**RE: Lot 1 Block 8 Unit 18 Volcano Cliffs SAD 228
6512 Papagayo Rd NW
Engineers Stamp Date 10/10/18 (D10D003O1)
Pad Certification Dated 10/10/18**

RE: **Volcano Cliffs Subdivision Lot 1, Block 8, Unit 18**
6512 Papagayo Rd. NW
Grading and Drainage Plan
Engineers Stamp Date 1/30/17 (D10D003O1)

From: Rael, Rudy E. <RRael@cabq.gov>
Sent: Thursday, January 19, 2017 10:03 AM
To: Metro, Steven J.
Subject: 6512 Papagayo

GRADING AND DRAINAGE PLAN

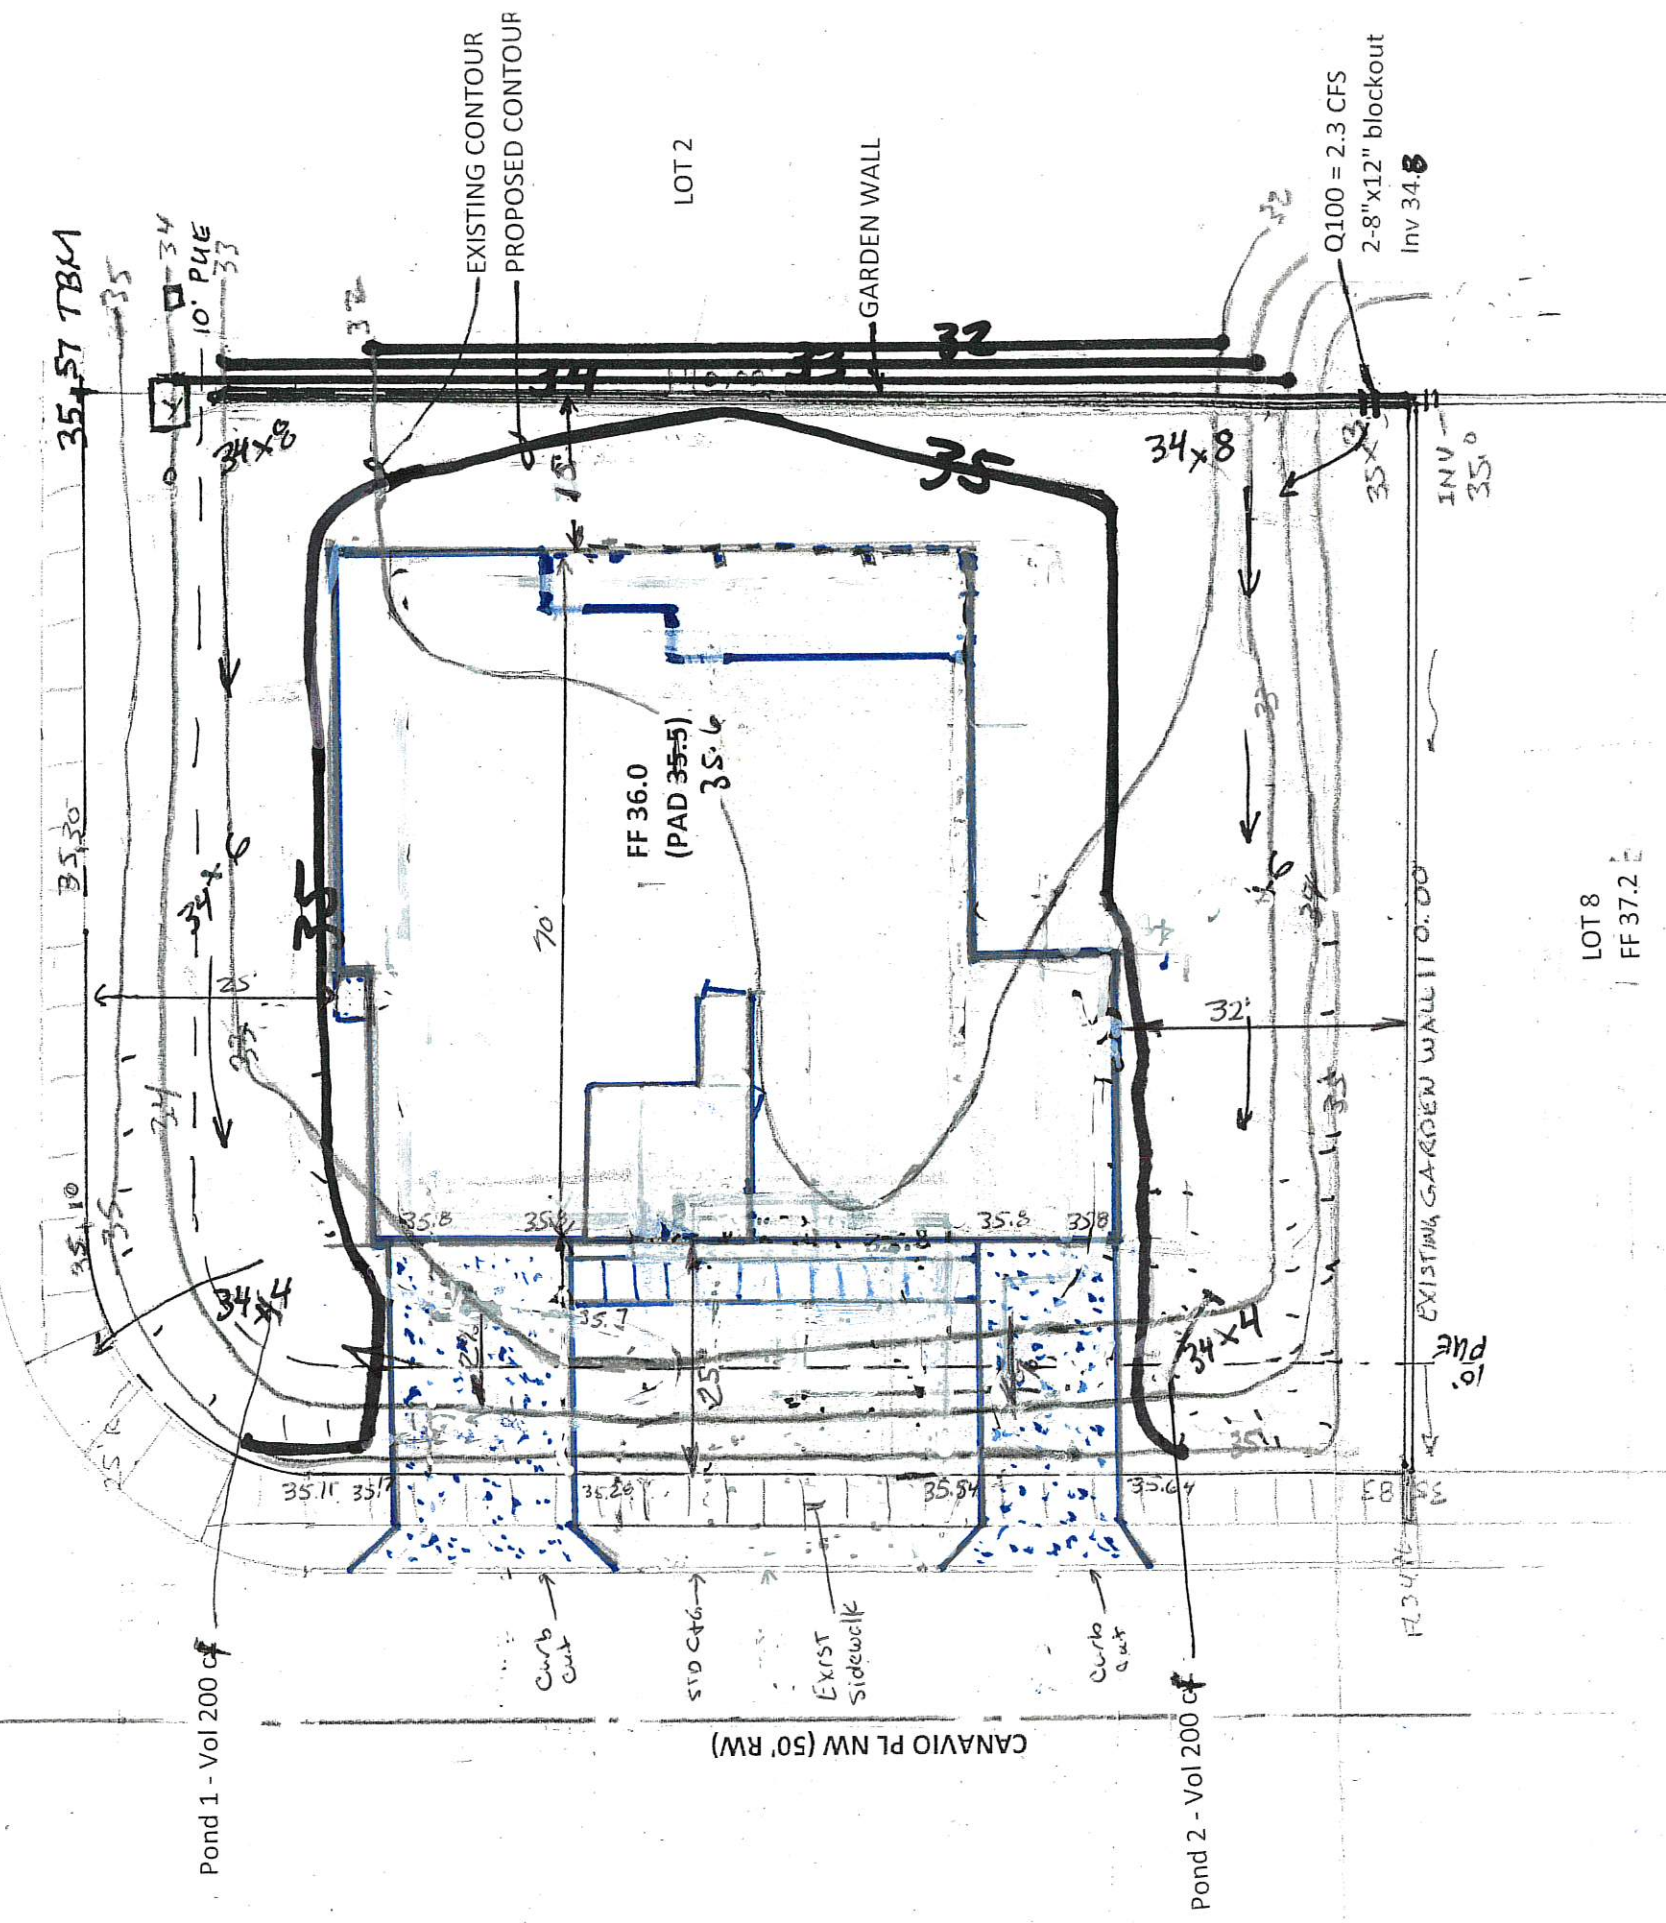
- Provide a note stating that future garden walls require a separate permit and this plan should be used for their placement.
- Also state that future garden walls require an opening 3" above grade in the SW corner.
- Provide a statement that a pad certification is required before a building permit is given.

- Note:
- 1. Future garden walls require a separate permit and this plan should be used for their placement.
 - 2. Future garden walls require an opening 3" above grade in the SW corner.
 - 3. A pad certification is required before a building permit is given.
